Lucan to City Centre Core Bus Corridor Scheme

NTA Observations on the Proposed Scheme CPO Objections

April 2023

Figure 2.1.10: Reduction in land take at eastern limit of Hermitage Golf Club Lands

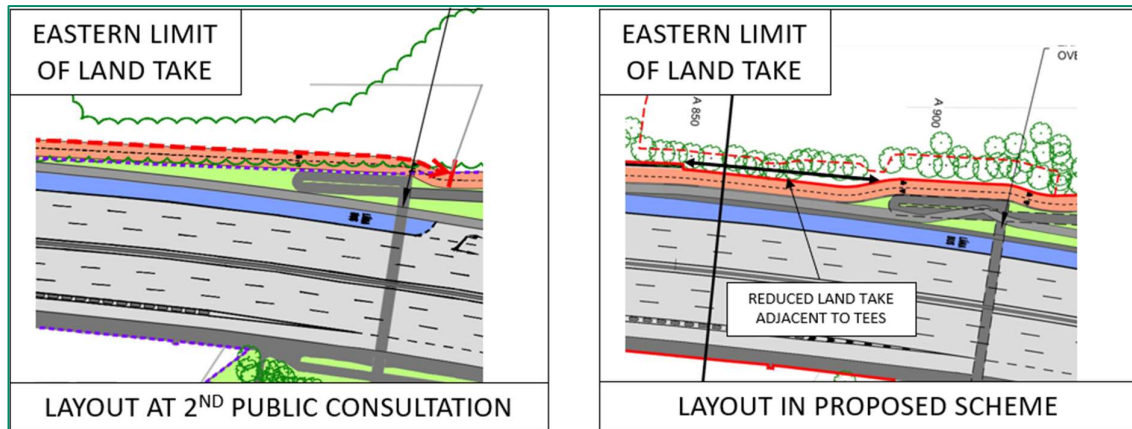
In response to the third round of public consultation, concerns were raised by the Hermitage Golf Club in respect of the impact of the two-way cycle track on their existing boundary with the N4, relating to the number of trees that would be lost. In particular, a suggestion was made that the two-way cycle track should be located on the south side of the N4 between the R136 Ballyowen Road and the existing pedestrian / cyclist bridge crossing the N4 immediately east of the golf club lands and west of the access to St Loman's Hospital.

Specifically, following the second round of public consultation and a meeting with representatives of the golf club, the cycle track alignment was amended to minimise the land take at the eastern end of the golf club lands close to two tee boxes. This is evidenced by Figure 2.1.10 which shows an extract from the scheme brochure presented as part of the second round of public consultation, as included in the Appendix to the Public Consultation Report 2018-2022 provided as part of the Supplementary Information provided with the application for the Proposed Scheme.

Figure 2.2.8: Proposed Continuous Bus Lane adjacent to Hermitage Medical Clinic

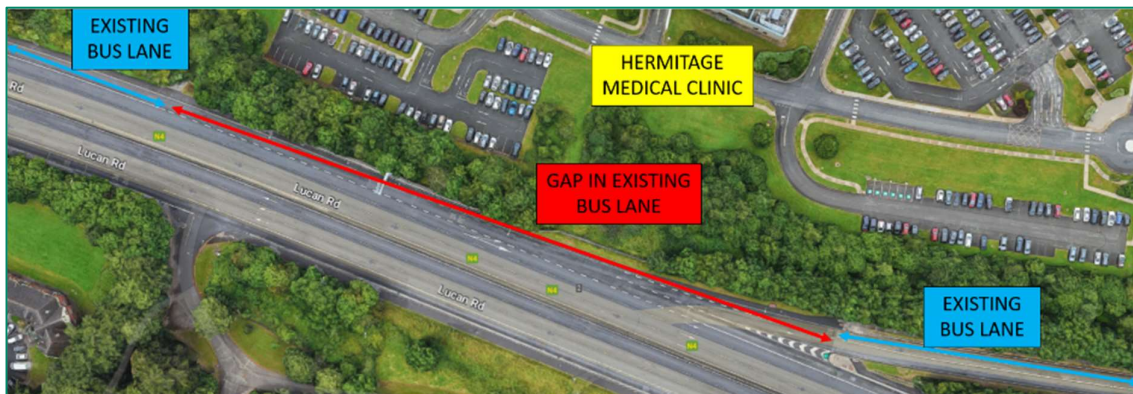
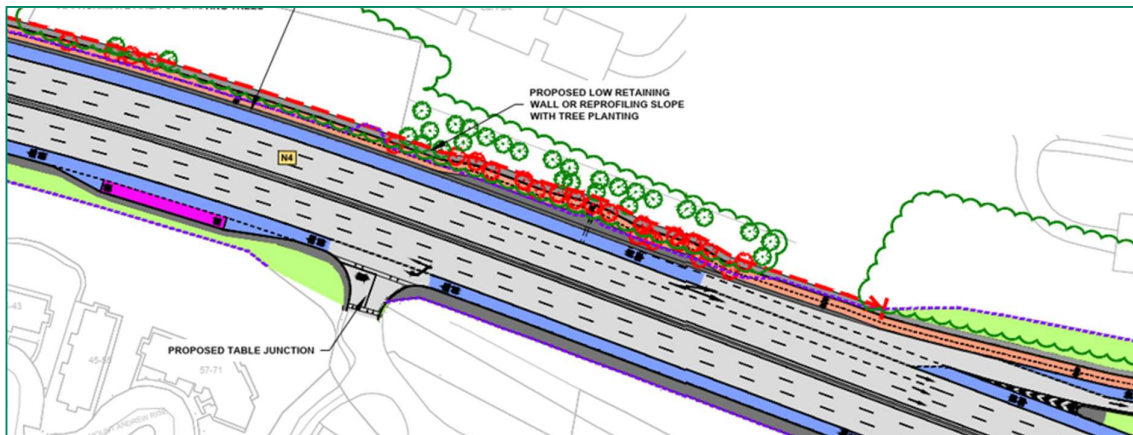
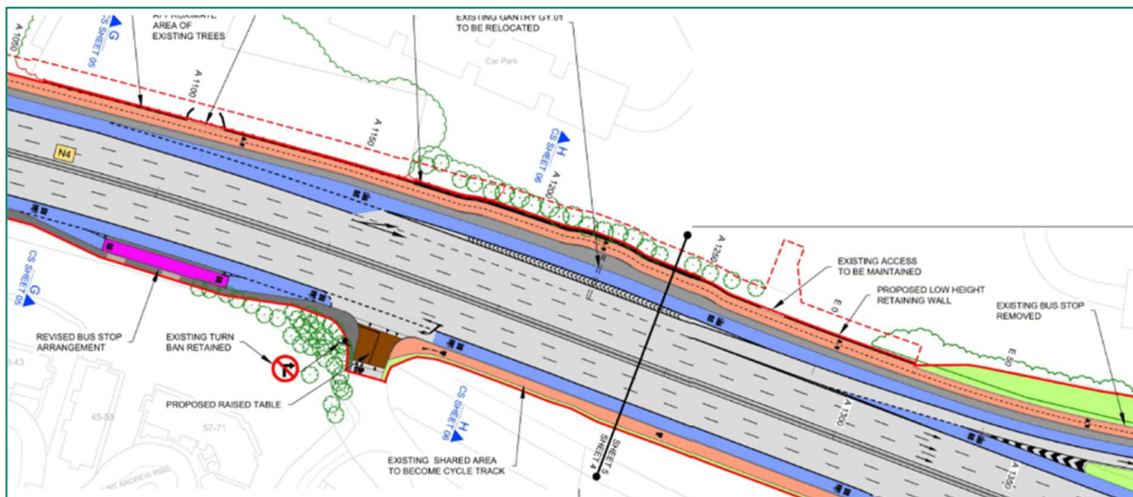
- i) The submission stated that the extents of the lands to be acquired are excessive, and unnecessary, for the implementation of the Proposed Scheme.
- ii) The submission stated that the Proposed Scheme (including the loss of mature trees) may be a Material Contravention of the SDCC Development Plan in respect of the “High Amenity” zoning of the land to be acquired and related policies. It also highlights that there is a significant view identified as to be protected in the Development Plan.

As shown in Figure 2.2.6 below the existing eastbound bus lane at the diverge for Junction 2 of the N4 is discontinuous, with a gap introduced by the parallel diverge lane for general traffic.

As set out in Section 3.4.2 of EIAR Chapter 3, the draft Preferred Route Option was published in March 2020 as part of the second round of public consultation; and Section 3.4.3 sets out how this was followed by a third round of non-statutory public consultation on the updated draft Preferred Route Option took place from the 04 November to 16 December 2020, In both these draft versions of the Preferred Route Option a gap was retained in the bus lane at this location, see Figure 2.2.7. While this arrangement included land acquisition for the proposed two-way cycletrack, it did not require any further land acquisition for the bus lane.

In July 2022 Transport Infrastructure Ireland (TII) published a new design standard DN-GEO-03087 entitled “Hard Shoulder Bus Priority Measures on Dual Carriageways and Motorways (July 2022)”. This standard is directly applicable for the N4 national primary road at this location where there already is a bus lane in lieu of a hard shoulder. In accordance with this design standard a continuous bus lane is required in situations where the bus lane follows the diverge lane, as is the case with the Proposed Scheme.

Therefore, the design alternative that formed the draft Preferred Route Option was no longer in accordance with the relevant design standard and the design was amended to include a continuous bus lane in the eastbound direction at the diverge to Junction 2 of the N4, as described in section 4.5.1.1 of Chapter 4 of Volume 2 of the EIAR, Proposed Scheme Description.

In summary the continuous bus lane on the eastbound carriageway of the N4 at this location, and the associated permanent and temporary land take, is necessary for the Proposed Scheme to comply with the appropriate design standard.

Figure 2.2.10: Location of Permitted MSCP Relative to Proposed CPO (Image Source: Google)

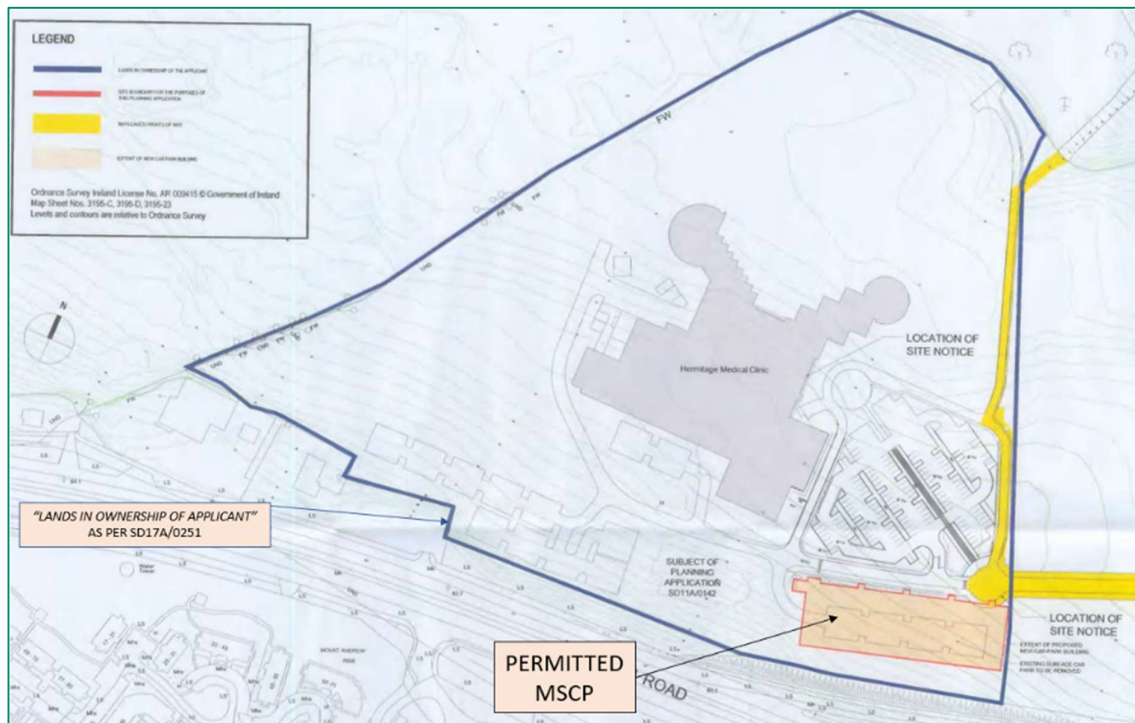
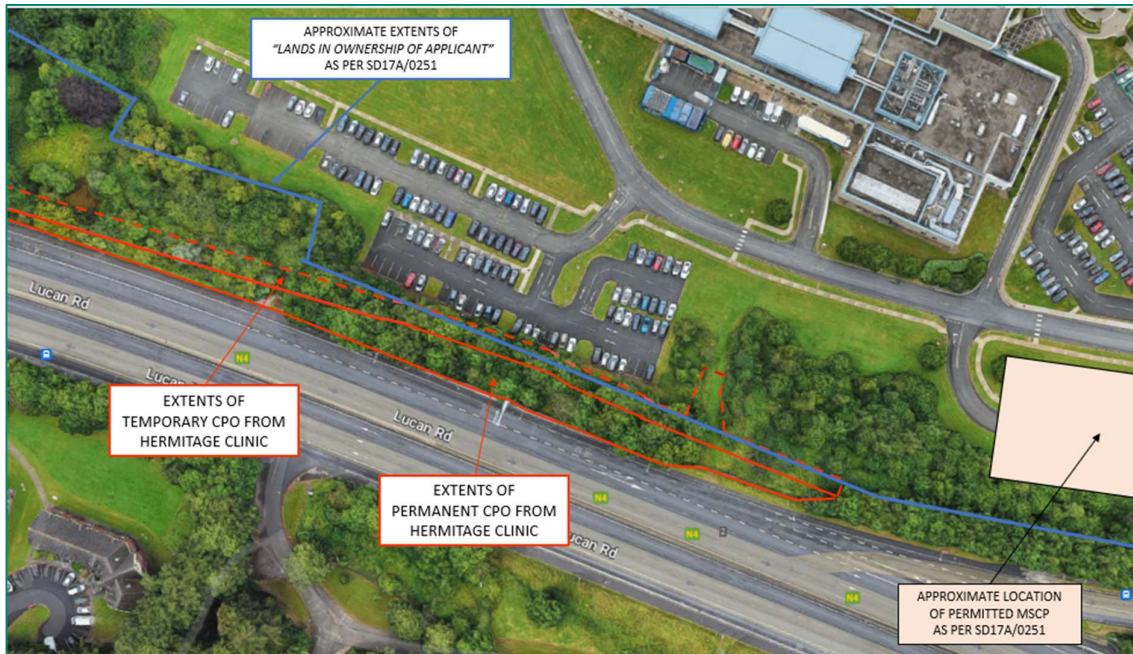
The submission asserts that the “lands immediately adjacent to the proposed CPO are therefore essential to the future expansion of the Hermitage Clinic. If the proposed CPO land take proceeds, it would significantly impact the Hermitage Clinic and the ability to accommodate further expansion of the clinic’s facilities in the future.”

In support of the above statement the submission refers to a planning permission for a multi-storey car park (MSCP), planning reference SD17A/0251. Figure 2.2.9 provides an extract from this permission and shows the location of the proposed MSCP. Figure 2.2.10 shows the location of the MSCP relative to the Proposed CPO.

The above Figures show that the permitted MSCP is not adjacent to the proposed land acquisition included in the CPO.

In addition, the Proposed Scheme adjacent to the Hermitage Medical Clinic as described in Section 2.2.1 earlier; and as shown in Figure 2.2.10 the proposed permanent and temporary land acquisition is limited to the planted side slope supporting the N4 and does not impact the existing car park.

Figure 2.2.12: Extract from Landscape General Arrangement drawings at Hermitage Clinic

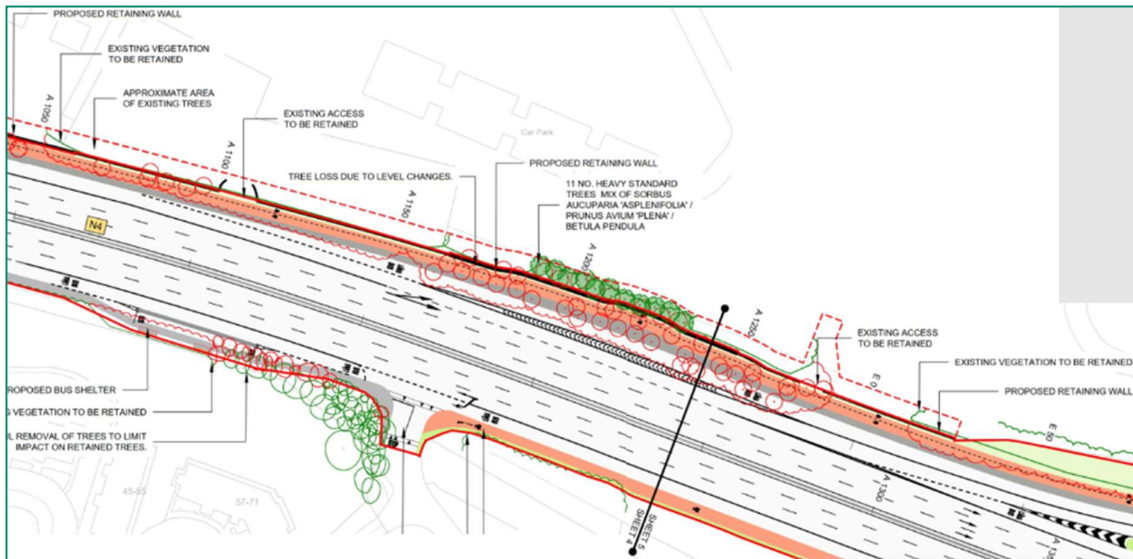
- v) The submission highlighted concerns about the planting works to replace the lost trees and expressed concern in relation to the height of the retaining wall on the Hermitage Clinic side of the proposed boundary.

In relation to the concerns raised about the planting works to replace the lost trees as a consequence of the Proposed Scheme, Section 4.6.12 of EIA Chapter 4 Proposed Scheme Description provides an overview of the landscape design principles and approach. Section 4.5.1.8.1 of Chapter 4 describes the approach taken in respect of the Hermitage Medical Clinic boundary and states that “Existing boundary walls will be set back and replaced to accommodate a 2m wide footway, 3.25m two-way cycle way and a 0.65m wide buffer strip adjacent to the proposed boundary wall. The existing boundary walls are to be demolished, relocated and reconstructed incorporating additional retaining structure elements where required.” It goes on to state that “Existing trees along the boundaries will be retained where possible and replacement planting will be proposed where appropriate”.

The Landscaping General Arrangement Drawings in the EIA, Volume 3, Part 1 of 3, Chapter 4 Proposed Scheme Description include 11 new heavy standard trees (defined as 12-14cm girth, 300-350cm height in accordance with BS3936-1) in the area of temporary land acquisition at the location where existing trees are lost, see extract in Figure 2.2.12.

Figure 2.3.11: Draft Preferred Route Option compared to the Proposed Scheme

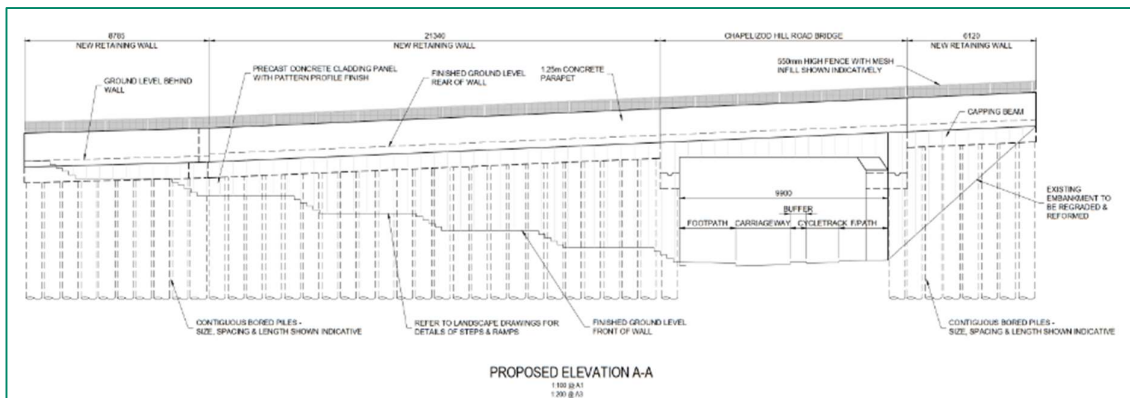
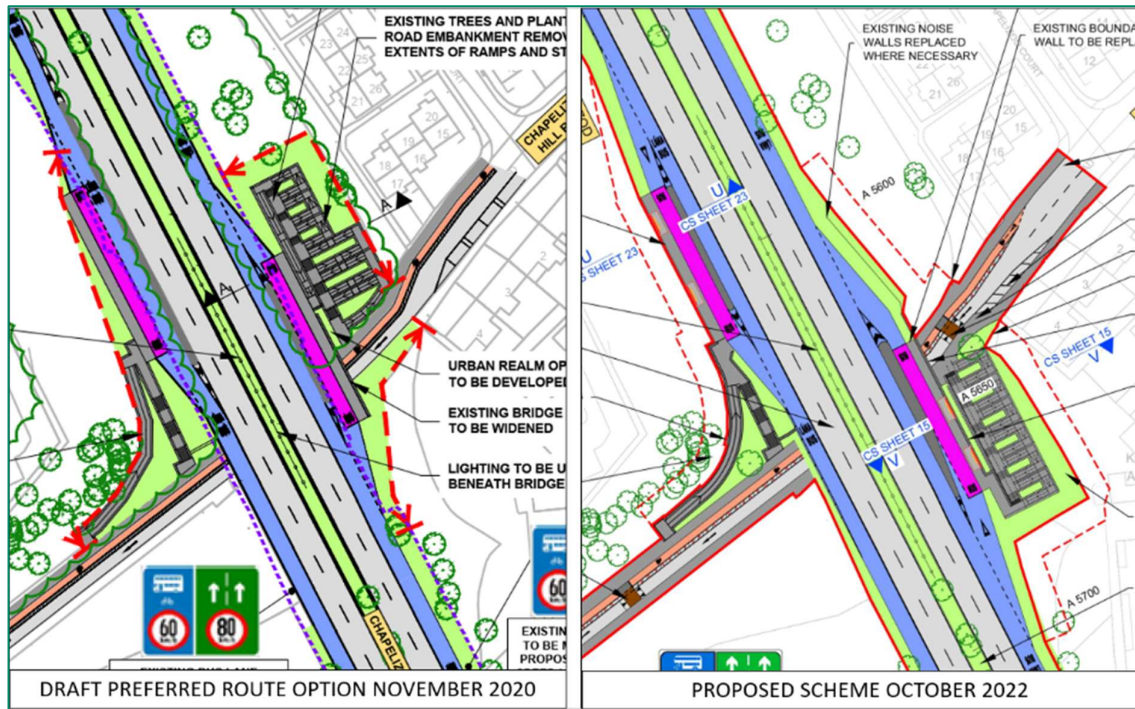
- i) The submission highlighted the scale and length of the proposed ramps and the existing steep slope to them from Chapelizod village. While recognising the benefits of providing access for all the submission questioned the demand from the village for the proposed bus services on the bypass and expressed the view that usage would be low. The submission suggested that a lift should be considered as an alternative solution and also questioned the consideration of alternatives in relation to the previous draft Preferred Route proposal for the ramps to be located on the north side of Chapelizod Hill Road, arguing that a greater number of residential properties are impacted by the Proposed Scheme than would have been impacted by the draft Preferred route proposals.

As described in Section 4.10.3 of the Preliminary Design report included as part of the Supplementary Information provided with the application for the scheme, the layout of the steps and ramps included in the Proposed Scheme are designed to have a maximum slope of 1 in 15 for sections of 5m, complying with Building Regulations Technical Guidance Documents K and M. The switch back design that interacts with the steps provides the most efficient layout and hence requires the minimum amount of landtake. In particular, as mentioned in Section 3.4.4.5 of Chapter 3, the overall length of the ramps is reduced in the Proposed Scheme from the layout on northern side of the road which was included in the draft Preferred Route Option. This reduced length arises from the height of the R148 Chapelizod Bypass being lower on the southern side of Chapelizod Hill Road, as shown on the Proposed Elevation of the Chapelizod Hill Road retaining wall shown on the Bridges and Major Structure drawings in EIAR Volume 3 Chapter 4 Part 2 of 2, see Figure 2.3.10. It is noted that the submissions states that the steps and ramps are “seeking to facilitate the c. 10m differential”. This is incorrect. The overall height of the ramps in the Proposed Scheme is approximately 5.0m, compared to approximately 7.0m for the previous alternative in the draft Preferred Route Option.

As identified in Section 3.4.2 of Chapter 3 Reasonable Alternatives, following the Draft Preferred Route Option Consultation (March 2020) one of the key changes included in the updated design of the Draft Preferred Route Option was that the new bus stops on Chapelizod bypass were lengthened, segregated and bus laybys introduced, with the existing bridge being widened on the north side.

Section 3.4.3 explains that further consideration following Updated Draft Preferred Route Option Consultation (November 2020) resulted in the new ramps and steps on Chapelizod Hill Road serving the proposed bus stops being moved to the southern side of the road, resulting in a reduction in height (reduced to 5.0m from 7.0m as described above) and a reduction in the overall length of the ramps from approximately 177m to approximately 138m, as well as reducing the overall area of the new facility, with environmental advantages associated with reduced earthworks, and reduced land-take.

As described in Section 3.4.4.5 this reduction in height and length had benefits for people using the ramps as well as requiring a reduced area and hence reduced loss of trees and vegetation. The Draft Preferred Route Layout and the Proposed Scheme layout are compared in Figure 2.3.11.
